WCAP-10126-NP-A

EXTENDED BURNUP EVALUATION
OF WESTINGHOUSE FUEL

SUBJECT: ACCEPTANCE FOR REFERENCING OF LICENSING TOPICAL REPORT
WCAP-10125(P), "EXTENDED BURNUP EVALUATION OF WESTINGHOUSE FUEL"

RESPONSE TO REQUEST FOR ADDITIONAL INFORMATION ON WCAP-10125

Figure 4

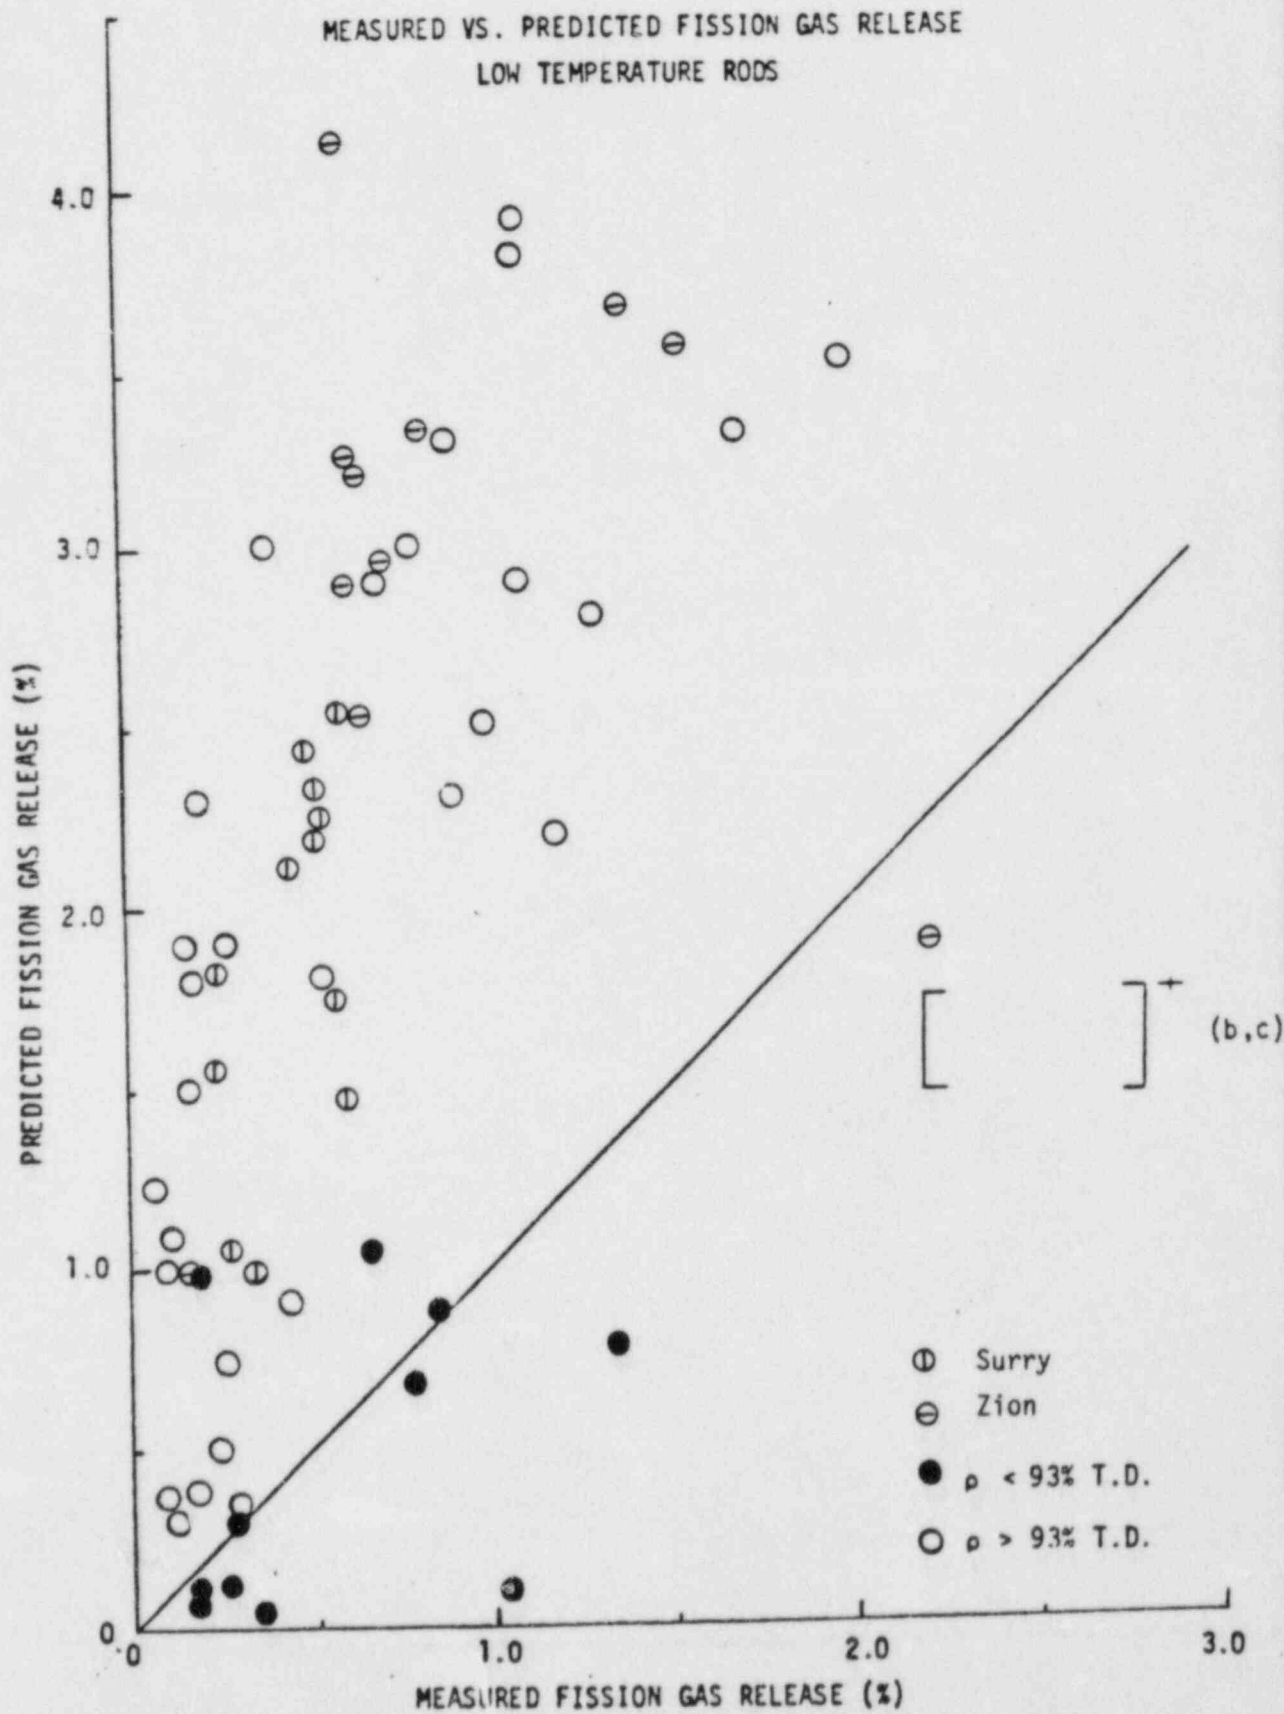
Fission gas release predictions for the Zion and Surry fuel rods are generally significantly higher than the measured fission gas release, as shown in Figure 4. (Figure 4 corresponds to Figure 3.6 in WCAP-10125, with additional points shown for the Zion and Surry rods.) This confirms that the Westinghouse fission gas release model gives conservative predictions for high burnup fission gas release for commercial reactor fuel operating conditions.
